Point Beach Nuclear Plant, Units 1 and 2  
Dockets 50-266 and 50-301  
Renewed License Nos. DPR-24 and DPR-27

License Amendment Request 261  
Extended Power Uprate  
Response to Request for Additional Information

#### LICENSE AMENDMENT REQUEST 261 EXTENDED POWER UPRATE RESPONSE TO REQUEST FOR ADDITIONAL INFORMATION

## EDG Voltage and Frequency Plots From Testing

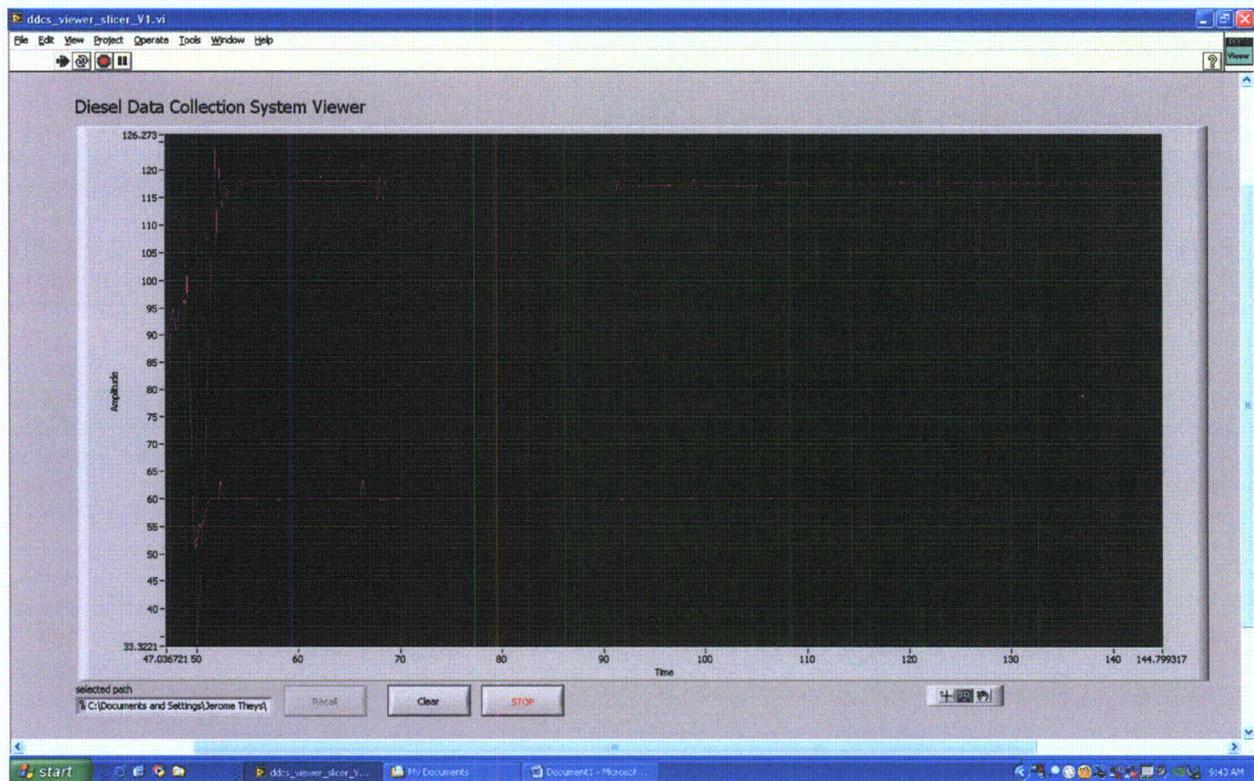
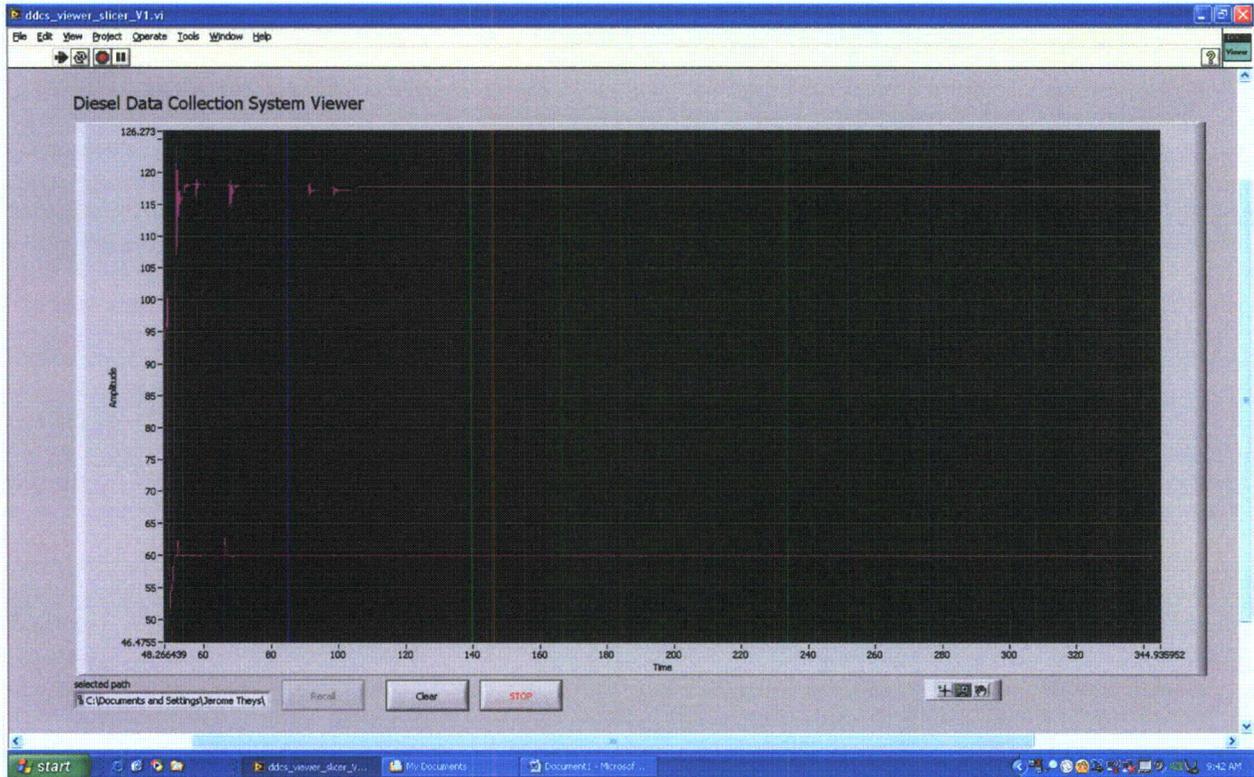
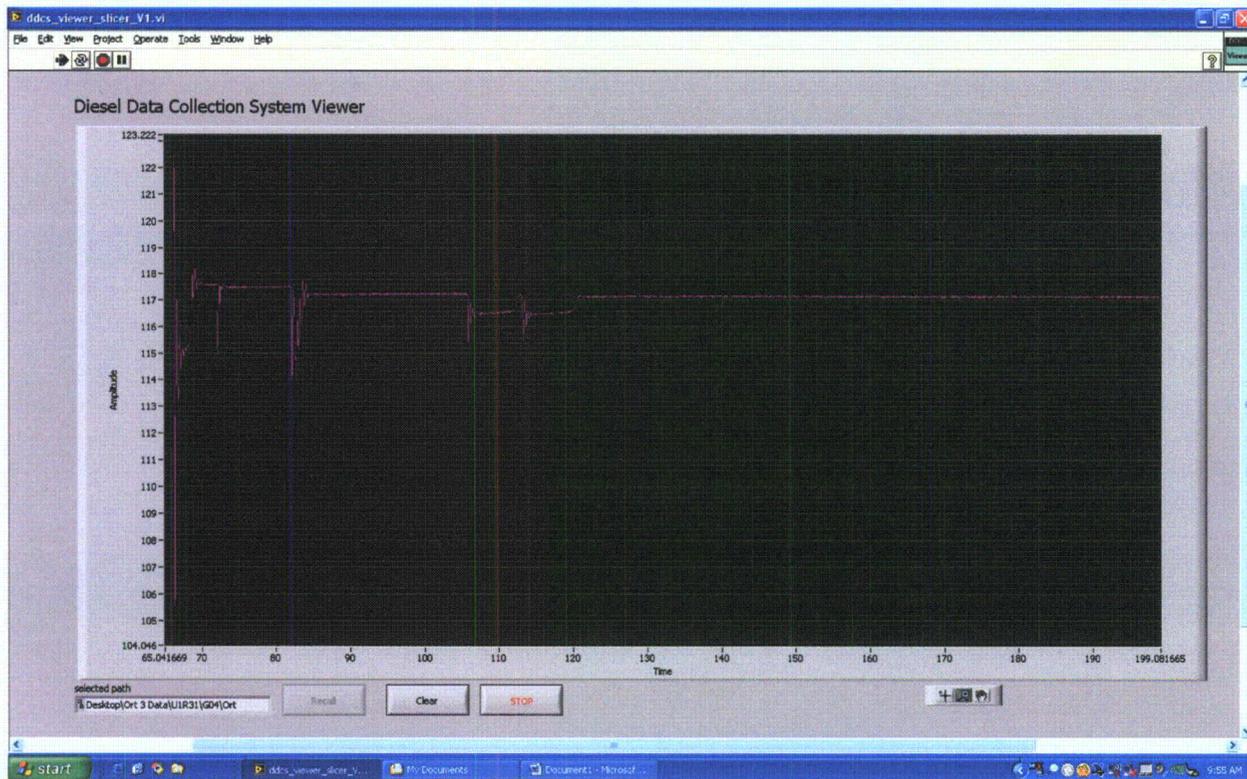
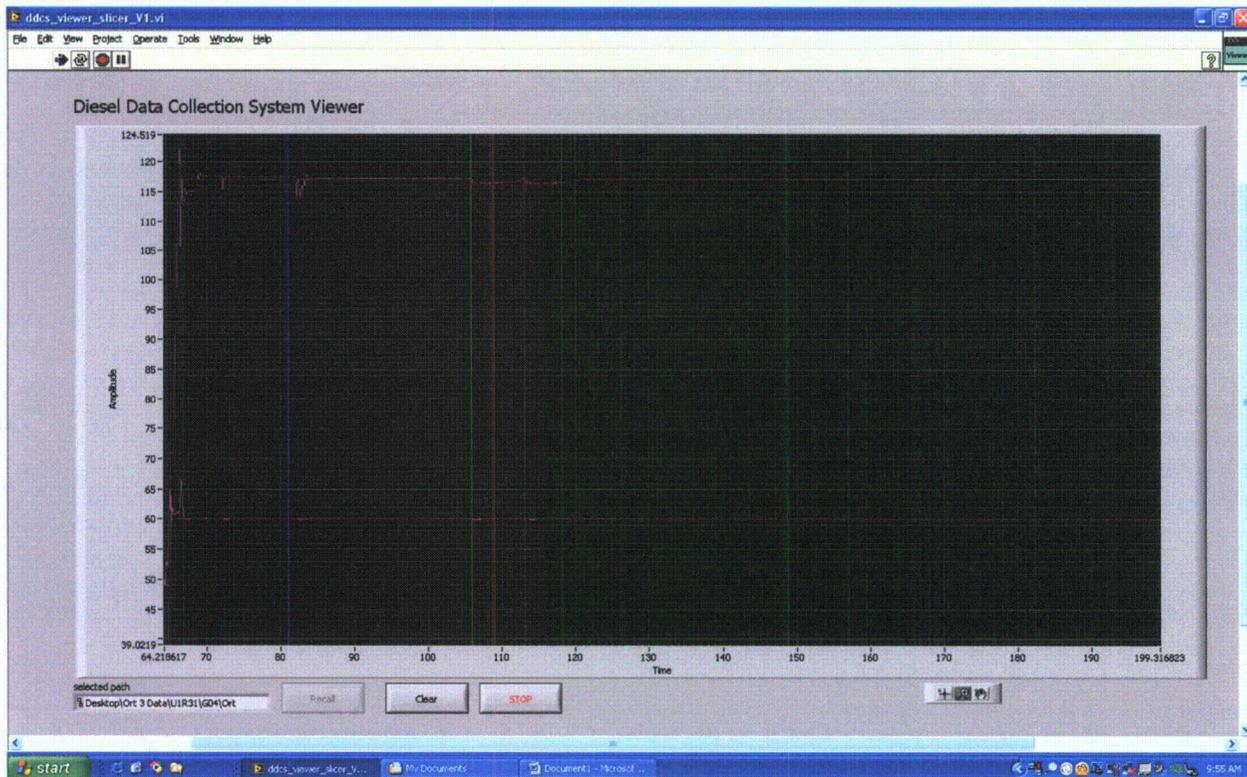
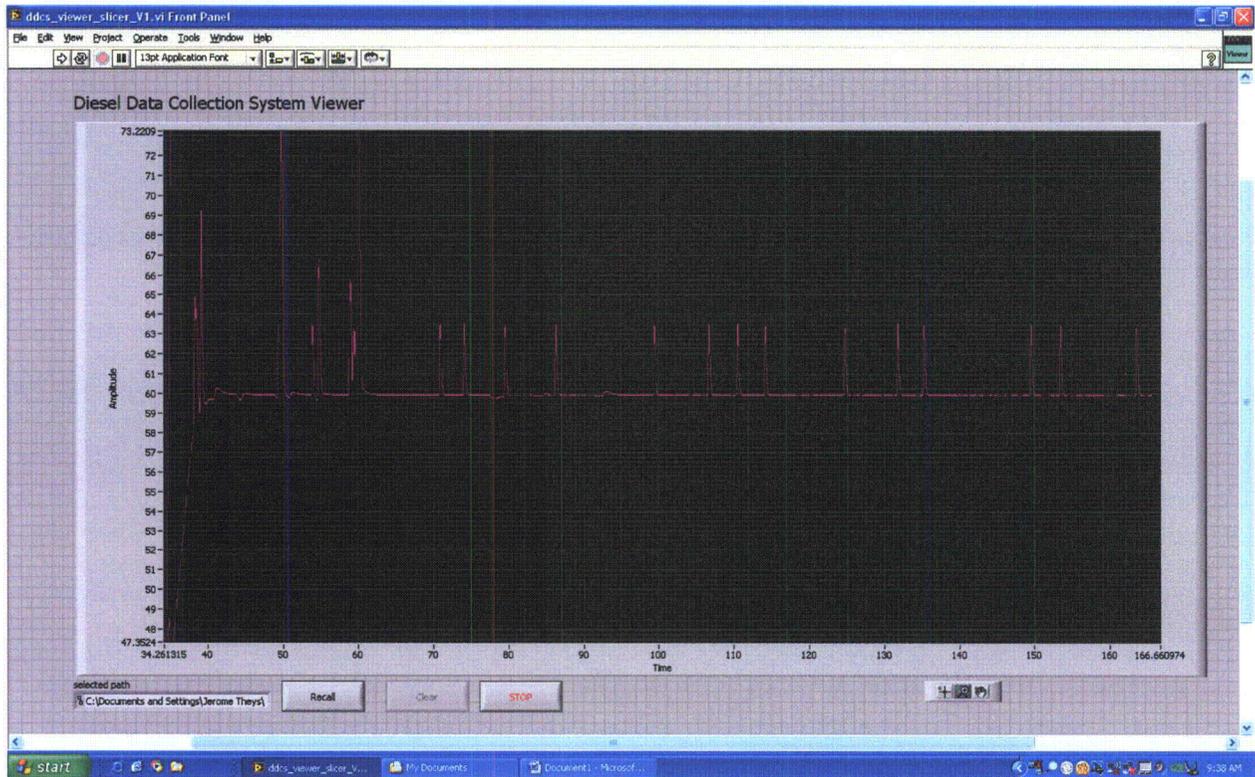
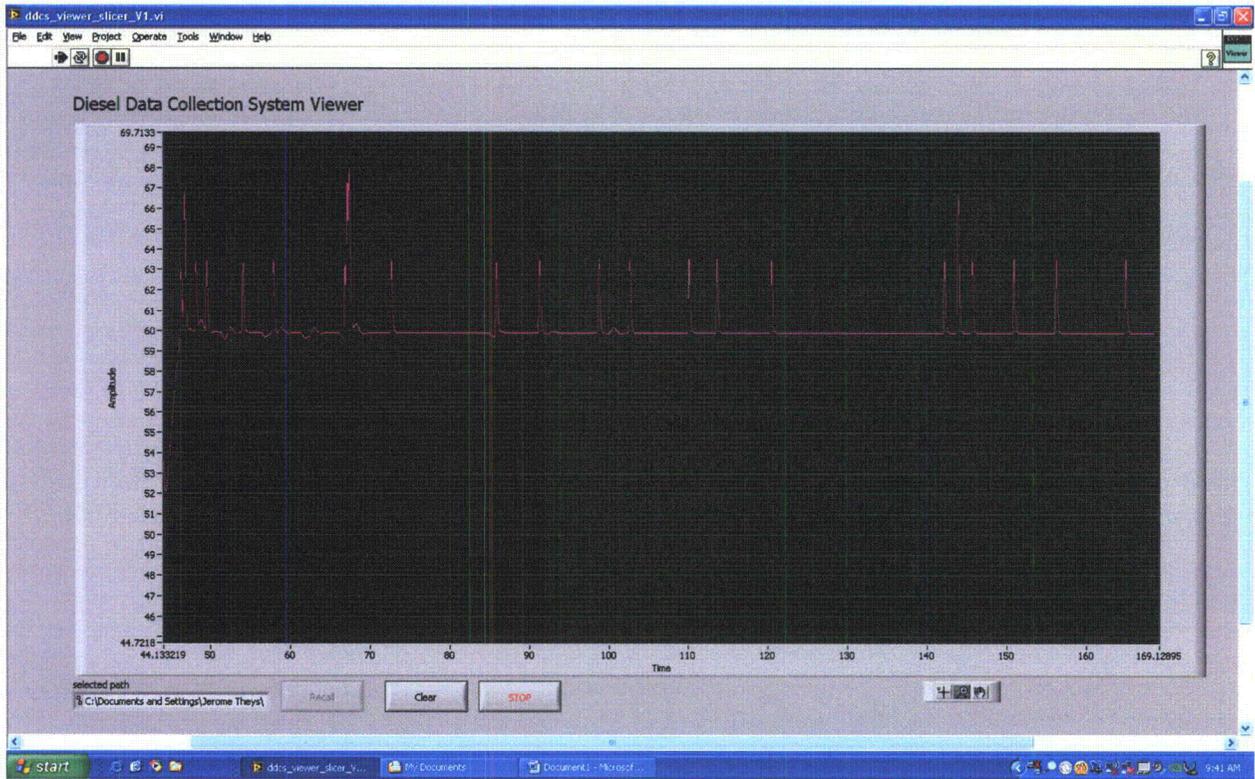
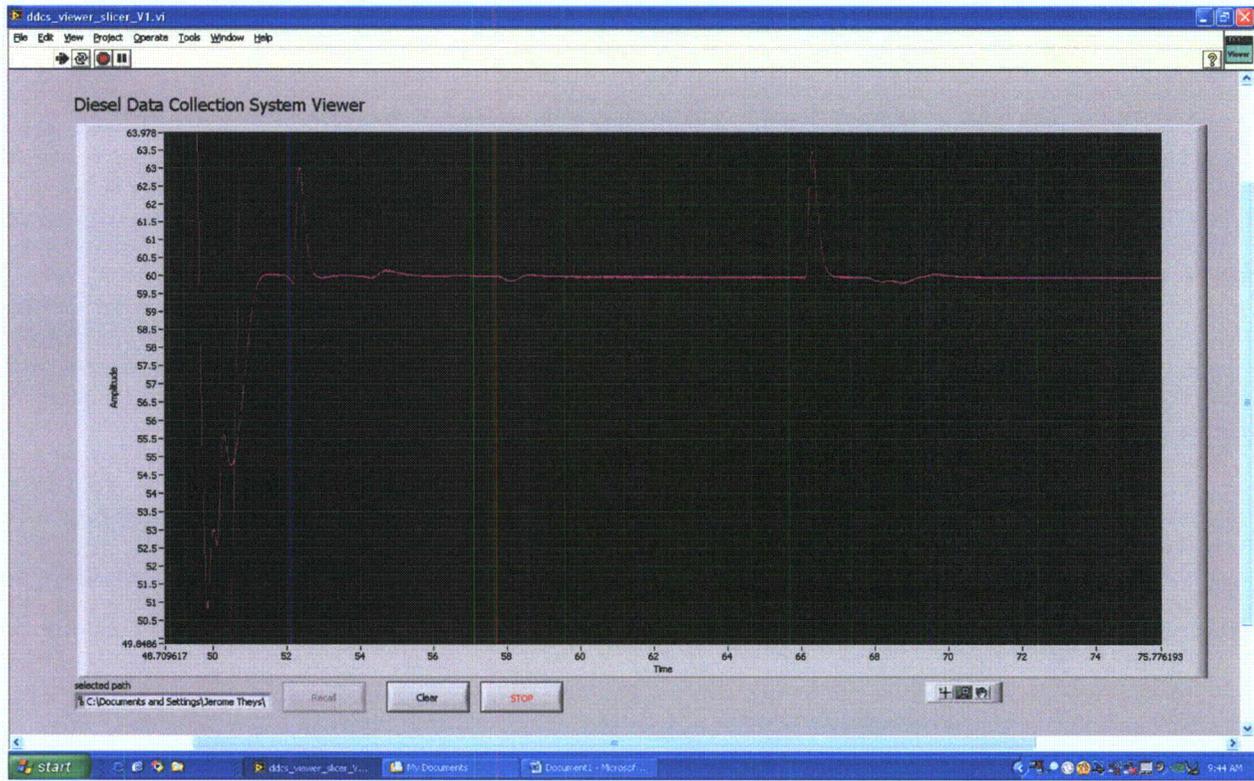
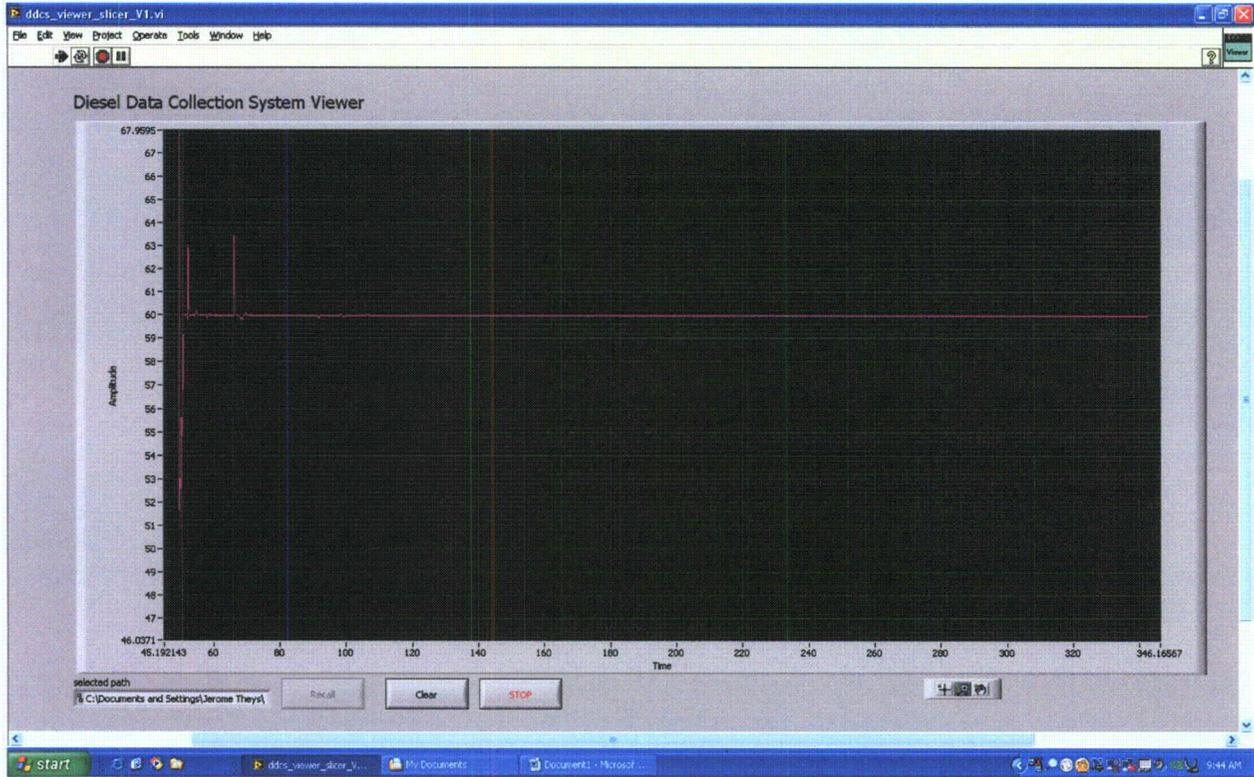
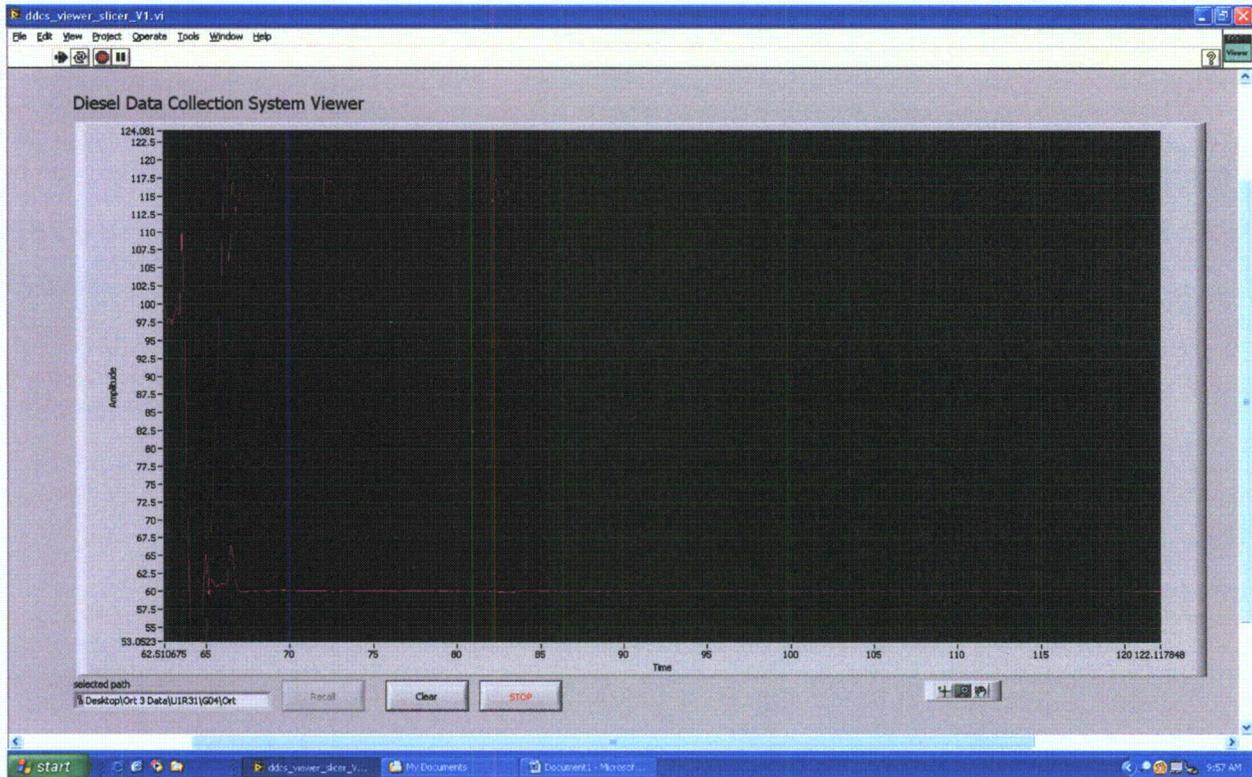
*The licensee stated that resulting worst-case calculated transient voltage dip is approximately 48 percent during the start of the motor driven auxiliary feedwater (MDAFW) pump at the time of emergency diesel generator (EDG) breaker closure. The staff notes that this voltage dip is well below the acceptance limit of 75 percent of nominal voltage during a motor start from the EDG. Please provide documentation (test data and transient analyses) to demonstrate that all loads (worst-case accident loads) can be sequenced successfully while maintaining the voltage and frequency within its design limits.*

*The licensee stated that the transient frequency response of all four EDGs remains above 57 hertz (Hz) at all times. Provide documentation to show that, during sequencing, the EDG frequency will be restored to within 2 percent of nominal in less than 60 percent of each load-sequence interval for step load increase and in less than 80 percent of each load sequence interval for disconnection of the single largest load. Also, describe how the effects of frequency variations have been evaluated to satisfy the design bases for emergency core cooling system loads and vital loads, including EDG loading.*

An engineering evaluation has been completed which demonstrates that the EDGs are capable of successfully sequencing all required electrical loads for the maximum design basis loading on the EDGs, including the loads from the upgraded auxiliary feedwater (AFW) system and alternative source term (AST) modifications. The calculation discussed above and evaluation demonstrate that the EDGs are capable of starting and accelerating all safeguards loads to rated speed within the time requirements of the accident analysis and the EDGs recover back to

nominal voltage and frequency. The calculation and evaluation show that the Train B EDGs remain above 75% of nominal voltage throughout the motor starting sequence in all cases. The Train A EDGs voltage will dip to approximately 48% of nominal voltage during the AFW pump motor start. The evaluation and calculation also show that this voltage dip will not impact the capability of the EDGs and safeguards loads from performing their specified safety function. The evaluation demonstrates that voltage recovers to acceptable levels (within  $\pm 5\%$  of 97.5% of nominal voltage) prior to a start of a subsequent motor.
